WPCP REHABILITATION PROJECT
PROJECT NO. 08-593-52-239

ADDENDUM NO. 4

March 30, 2011

SKETCH 4.09 - DRAWING 24-M-03

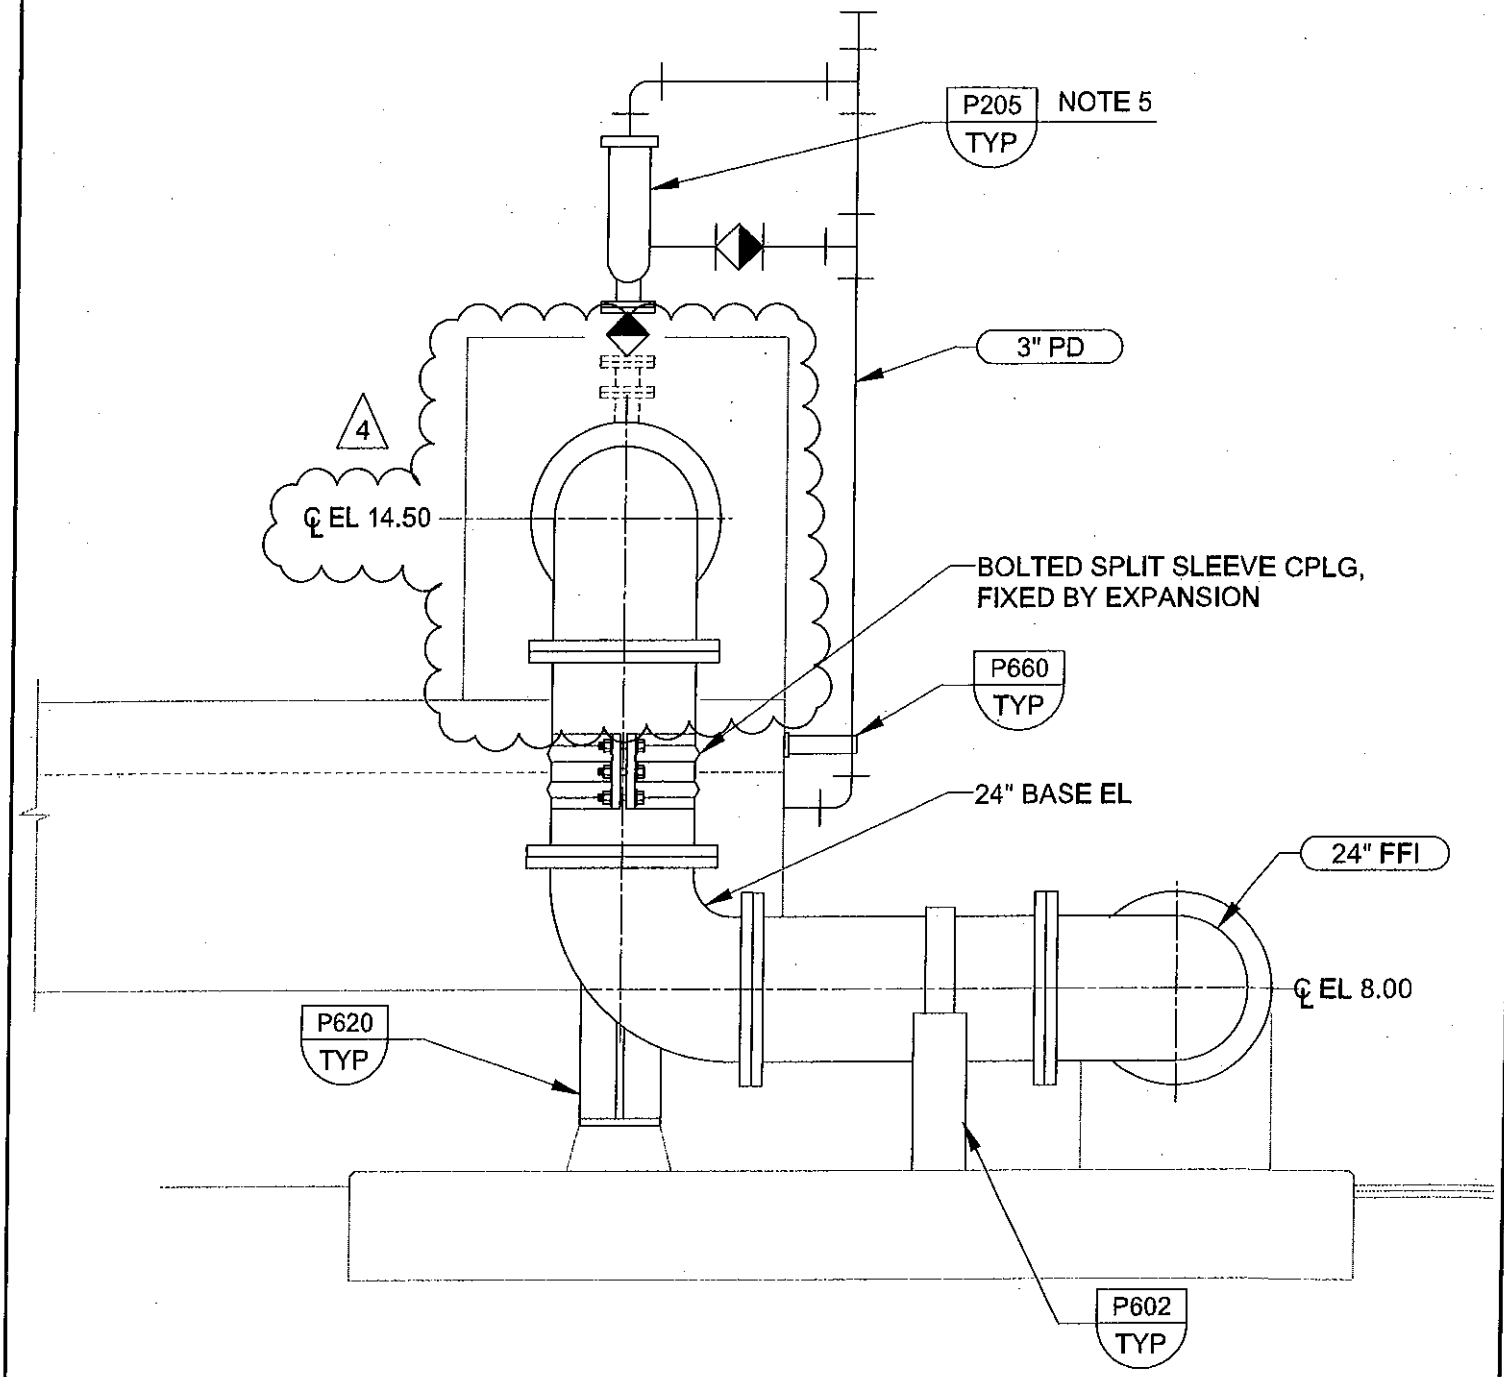
Item 4.76 **Drawing 24-M-03** – Revise Section D as shown on the attached Sketch 4.09.

SKETCH 4.10 - DRAWING 24-M-03

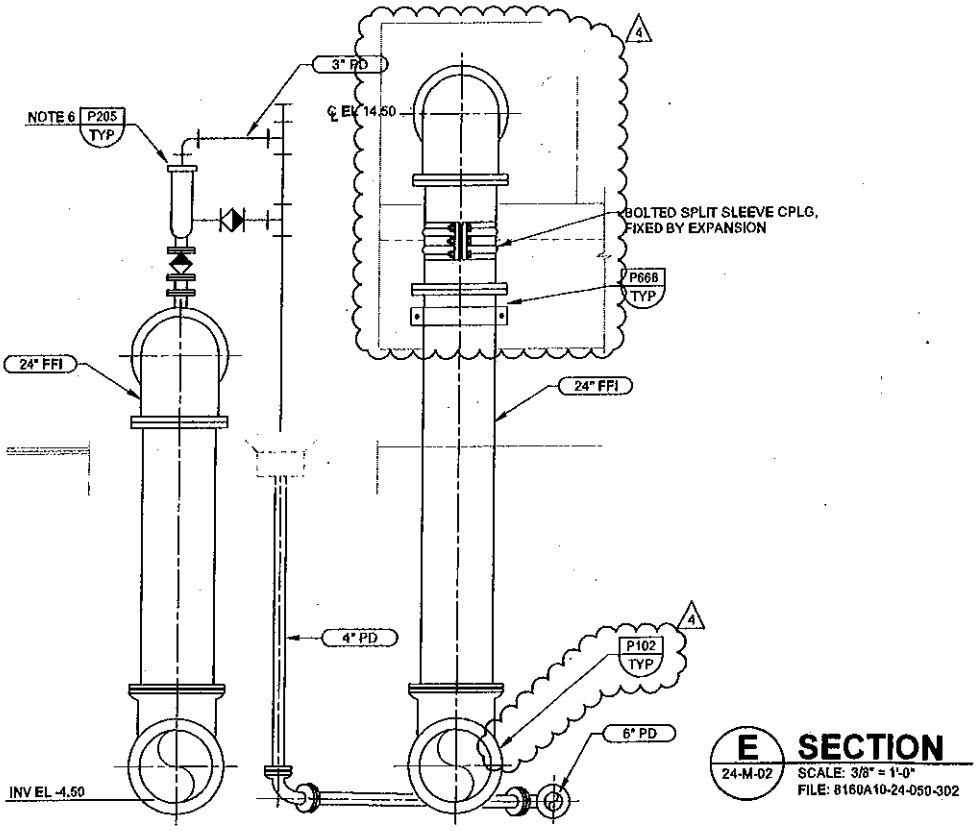
Item 4.77 **Drawing 24-M-03** – Revise Section E as shown on the attached Sketch 4.10.
